Subject: Bangor Savings Bank

Windham Branch/Office Parking Expansion Response to Staff Review Comments

WINDHAM, MAINE

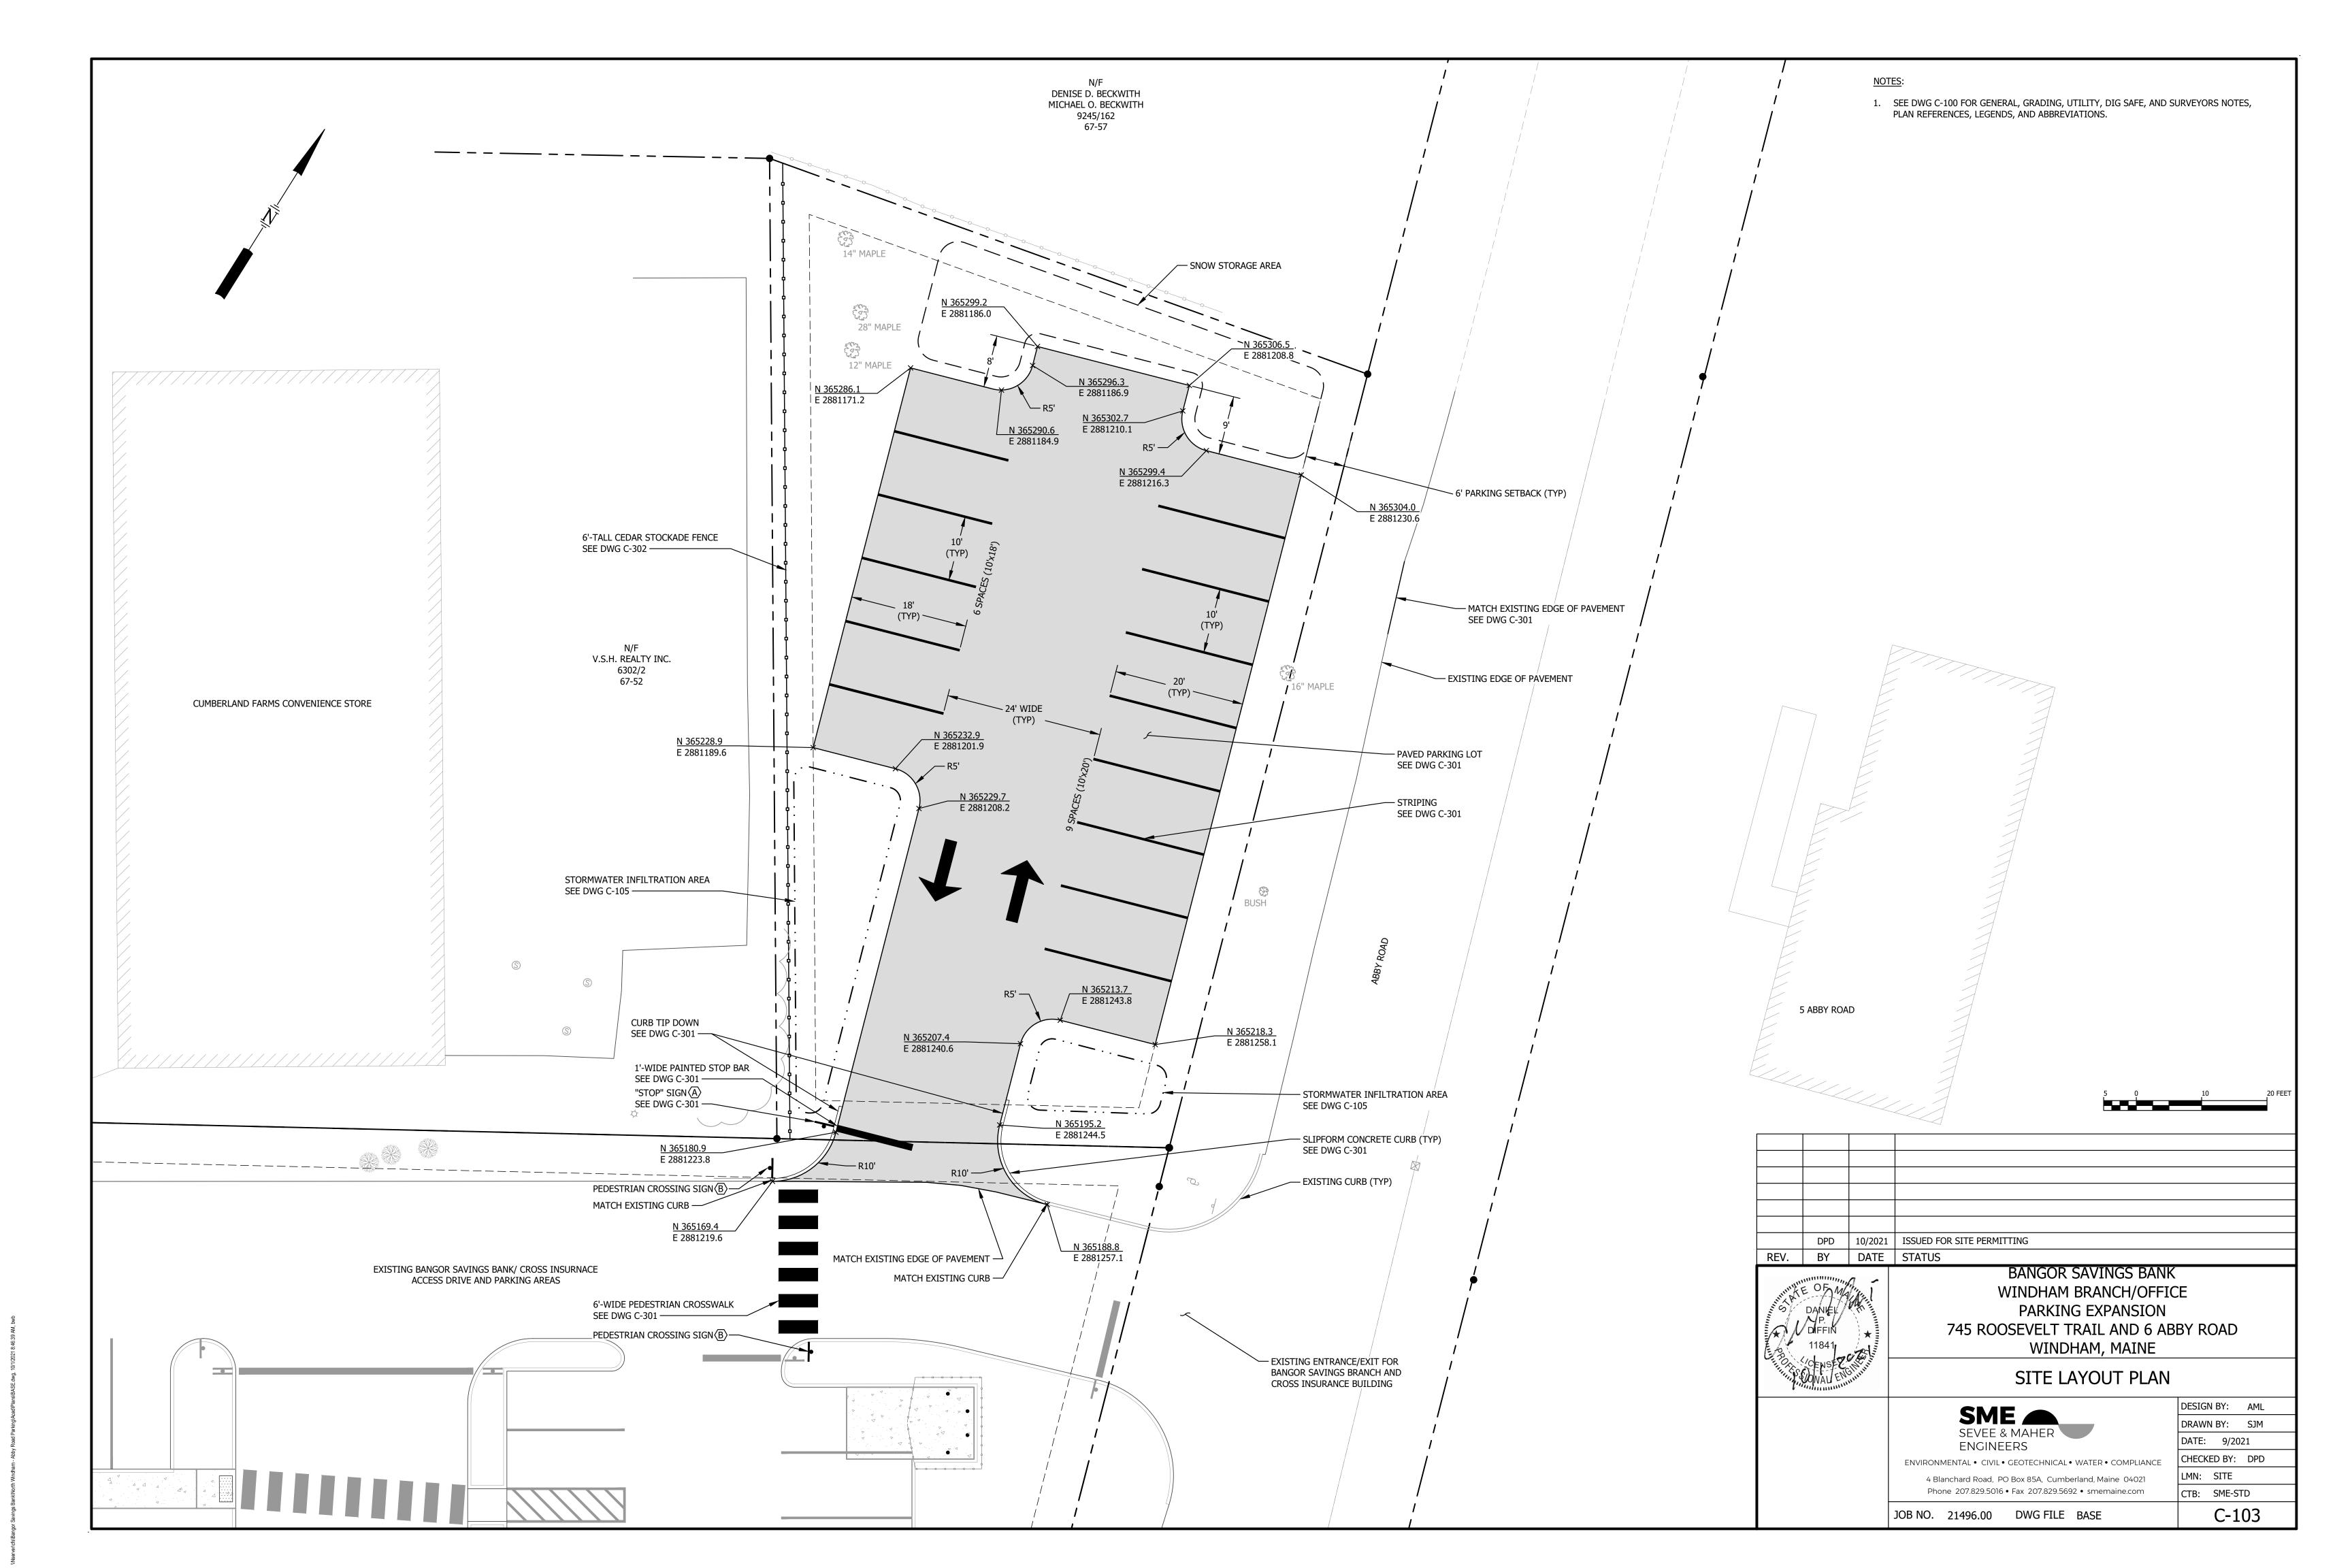
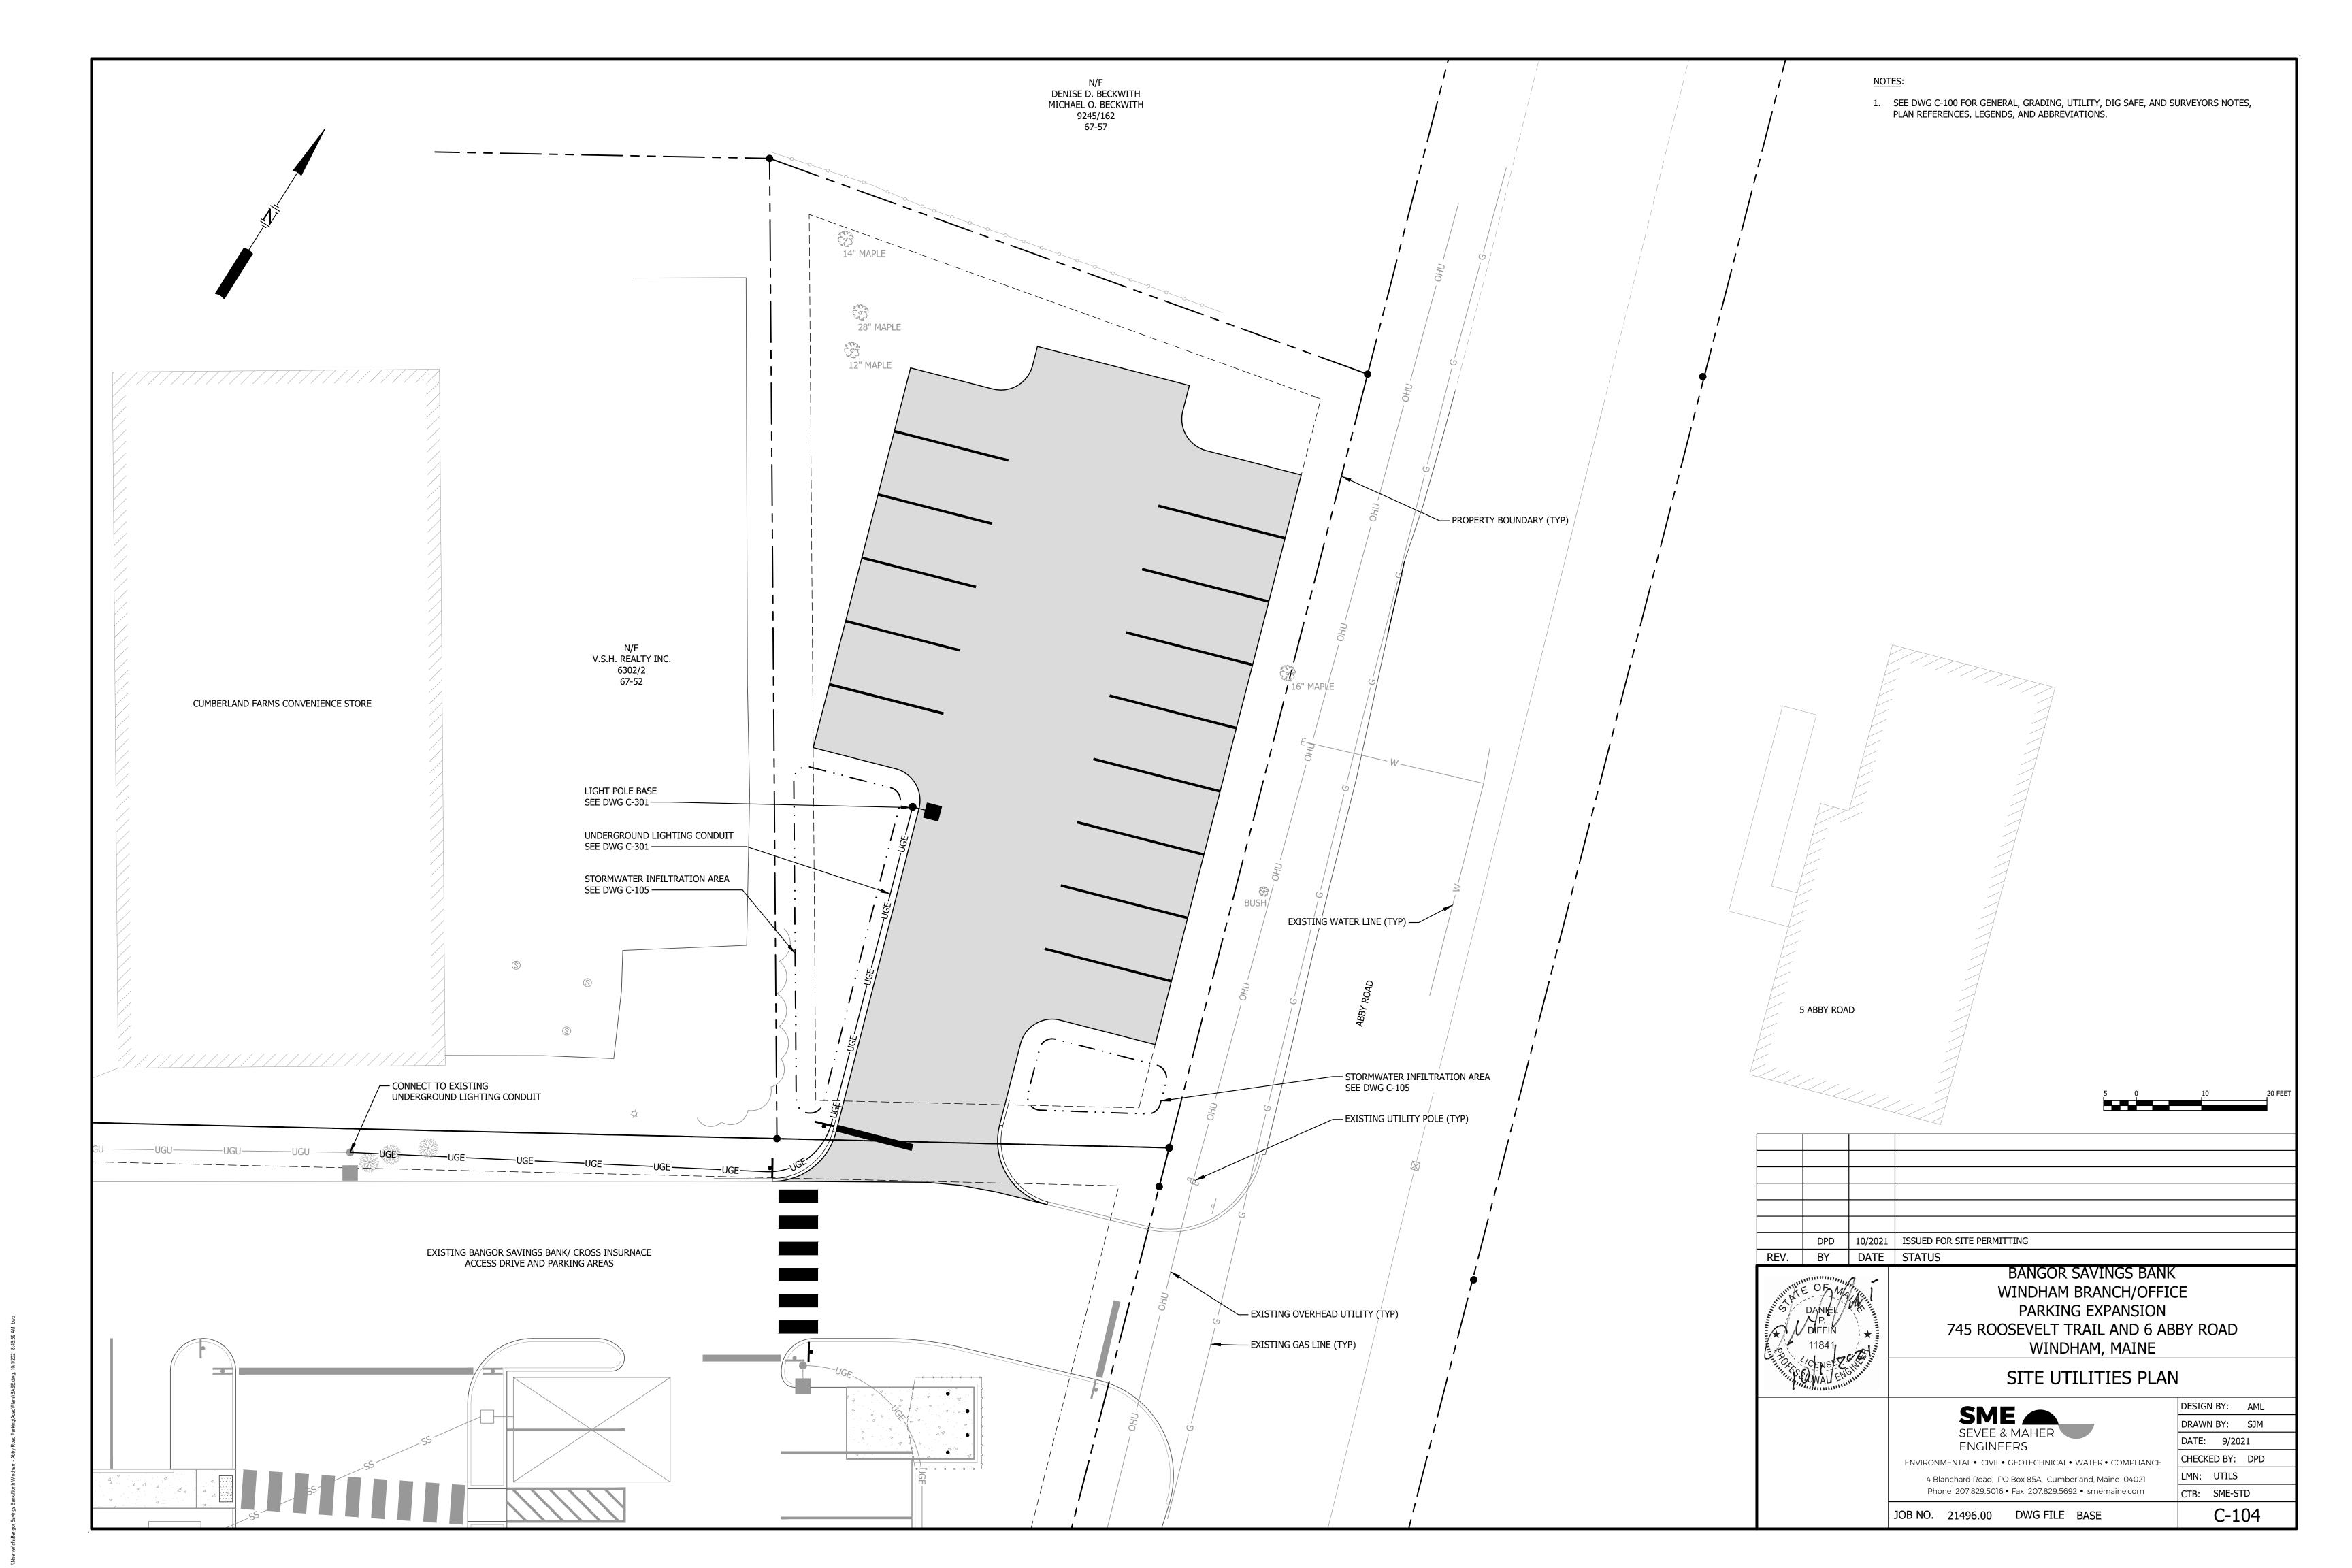
4. Please add "Amended" in the title block of Sheet C-102.

9. Please add the following

<u>SME Response</u>: Project plans have been updated to include "Amended" on Sheet C-102. A copy of the updated plan set is attached for reference.

<u>SME Response</u>: The Conditions of Approval were added to Sheet C-102. A copy of the updated plan set is attached for reference.
